MEMORANDUM

DATE: 04 July 2023
TO: Northern Beaches Local Planning Panel (NBLPP)
FROM: Adam Richardson A/Executive Manager Development Assessment
SUBJECT: Item No. 5.2 – DA2022/2232 – 152-154 Sydney Road, Fairlight
TRIM REFERENCE: 2023/421637

15. Stepped roof to Stair 4

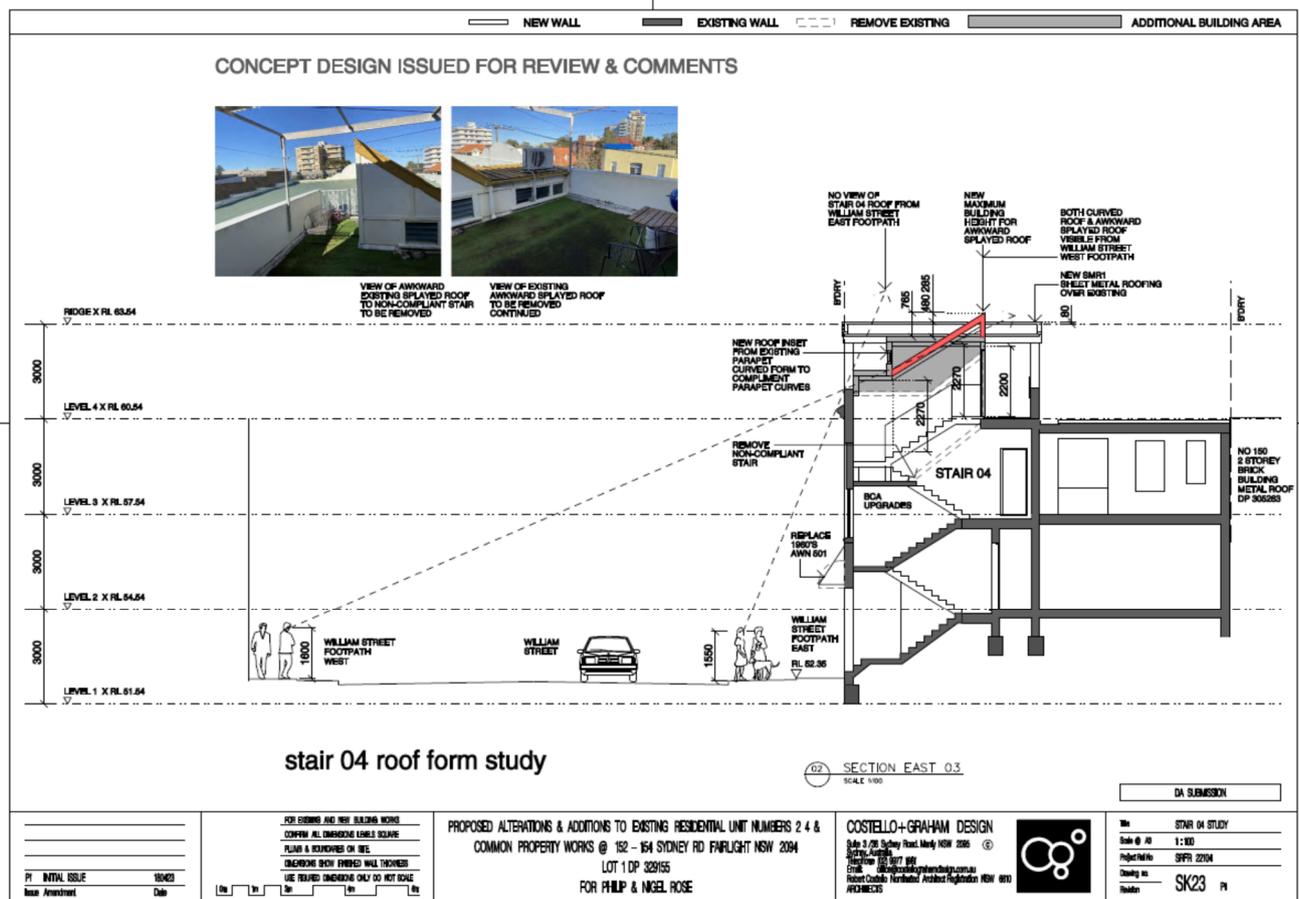
The height of the proposed curved and stepped roof to stair 4 is required to be changed to a pitched roof form or alternatively be reduced by minimum 200mm including the landing.

Applicant's rebuttal – The proposed requirement to reduce the curved stair height by 200mm cannot be achieved on site as the existing ceiling height proposed is only 2.2m and a standard 2.1m door frame will not fit below the required condition 15 ceiling height of only 2.0m. There will also be no ceiling room available for essential building services including emergency lights & exit signs if this unreasonable impracticable & BCA non-compliant condition is imposed.

Alternatively, if the proposed condition 15 requires a splayed roof similar to the existing "awkward" roof form, this resultant element will increase the overall building height by an additional 285mm above the existing non-compliant roof height and will provide a new maximum building height. Refer SK 23_P1, previously issued to council.

It is noted that the proposed stair 04 roof form cannot be seen from the eastern William St footpath and is lower than the existing roof in its proposed form. The consequences of this condition do not

improve the building aesthetics or visibility and are unreasonable. The proposed curved roof form is designed to complement the curved parapets.

The condition provides 2 options for the Applicant to consider, being (1) change the roof to a pitched roof form (not a splayed form as suggested in the rebuttal above) or (2) alternatively reduce the current proposed roof form by minimum 200mm including the landing. The BCA and NCC stipulate a minimum ceiling height for stairways of 2 metres, not 2.2 metres or 2.1 metres as required for habitat rooms or kitchens and bathrooms. Therefore, the condition to reduce the roof form and landing by 200mm can be achieved and will be compliant with the BCA and NCC requirements.

Heritage do not support the condition being changed or removed.
